Cree® XLamp® XHP35.2 LED Product Change Notification

PCN Reference Number: CREE-PCN-1253

Date Issued: January 7, 2021

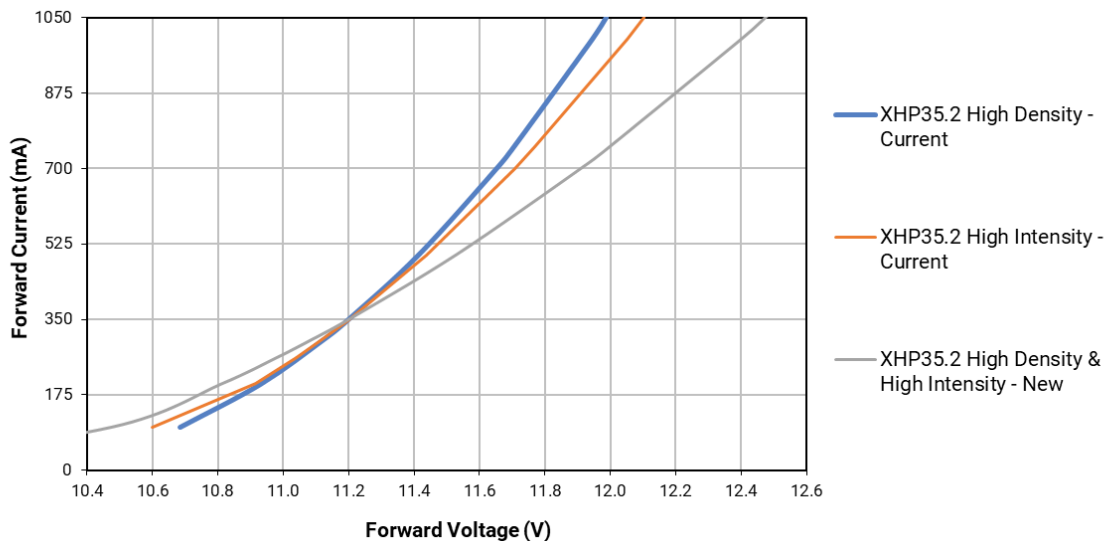
Cree will be changing the voltage characteristics for XLamp XHP35.2 High Density and XHP35.2 High Intensity LEDs. The following graph shows the updated Forward Voltage vs. Current curve.

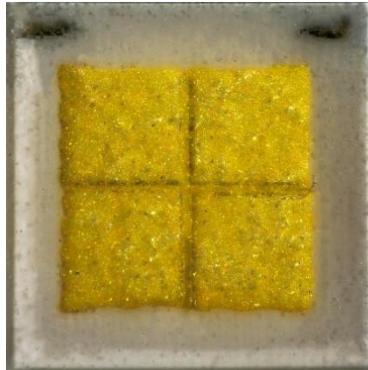
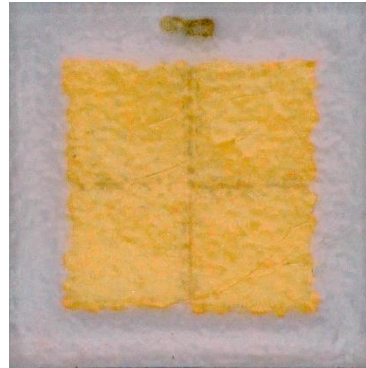
Cree will be changing the ESD die configuration inside both the XLamp XHP35.2 High Density and XHP35.2 High Intensity LEDs. The change is shown in the photos of the High Intensity version below.

Current (2 ESD die)

New (1 ESD die)

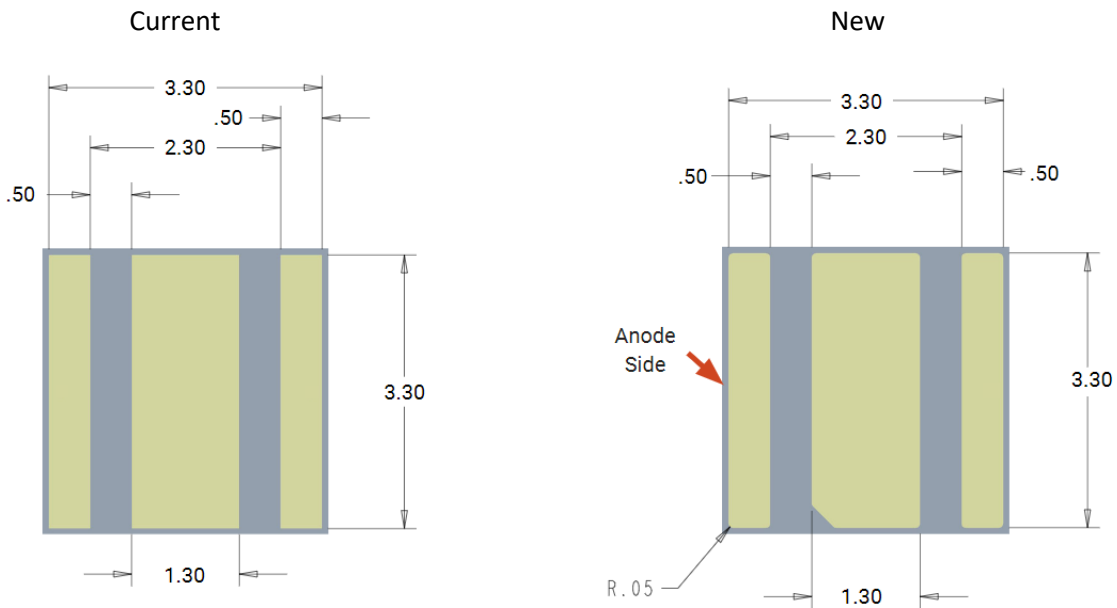
Cree will also be changing the polarity indicator for XHP35.2 High Density LEDs from a top-side circle marking the cathode side to a bottom-side notch in the thermal pad. This new polarity indicator for XHP35.2 High Density is the same design used on the XHP35.2 High Intensity.

The current and new bottom-side designs for XHP35.2 High Density are shown below.
